STAFF RECOMMENDATION

1004 Acklen Avenue

December 21, 2016

Application: New construction—addition

Figure 2 (top) is a photo showing the existing door to be removed and the double window opening. Figure 3 (below) is the proposed new side facade.

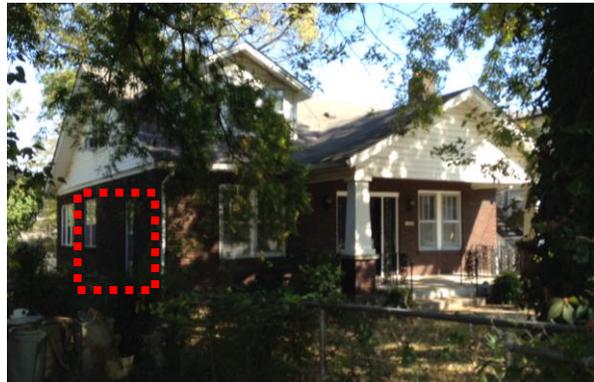
Partial Demolition: The applicant proposes to change a side door opening into a window opening (Figure 2). The side door does not appear to be original, and staff finds that the new window opening is appropriately scaled. Staff finds that removing the door opening and creating a window opening meets the design guidelines as it will still be an opening. The applicant indicates that no other window or door openings will be changed. However on the left elevation, the double window opening that appears in the photo is drawn as a single window opening (Figure 3). Staff recommends that the drawings be updated so that the correct existing window pattern is shown.

1. Staff receive revised drawings showing that only the existing side door opening will be altered on the left façade;
2. Staff receive more information regarding what will happen to the existing foundation underneath the rear porch that is to be removed;
3. The siding be wood or smooth face cement fiberboard with a maximum reveal of five inches (5”);
4. Staff approve the final details, dimensions and materials of windows and doors prior to purchase and installation;
5. Staff approve a masonry sample;
6. Staff approve the roof color, dimensions and texture; and
7. The HVAC shall be located behind the house or on either side, beyond the mid-point of the house.
